CONSOLIDATING STEM AND DIAPHRAGM NUT IN 2"-3" PBT LEVER OPERATED DUMP VALVES

This product notice is to inform you that we are consolidating the stem and diaphragm nut into one stem on all 2" and 3" Piston Balanced Lever Operated Dump Valves.

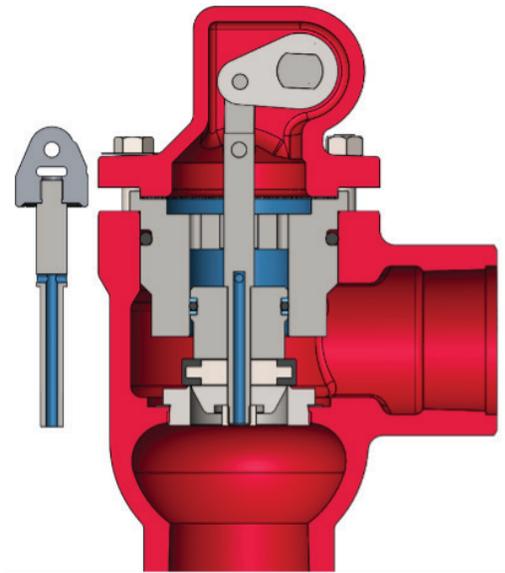
- Reduced number of components in the PBT Lever Operated Dump Valve
- Time savings on disassembly and reassembly
- Tighter tolerance in the link pin hole to help reduce rotational play in the lever arm

On the left is shown the old style stem with diaphragm nut attached. The new stem is shown installed in the valve.

Note that the diaphragm nuts listed above will not be discontinued since they will still be used in the Diaphragm Balanced Valves.

The current stems listed above will be discontinued.
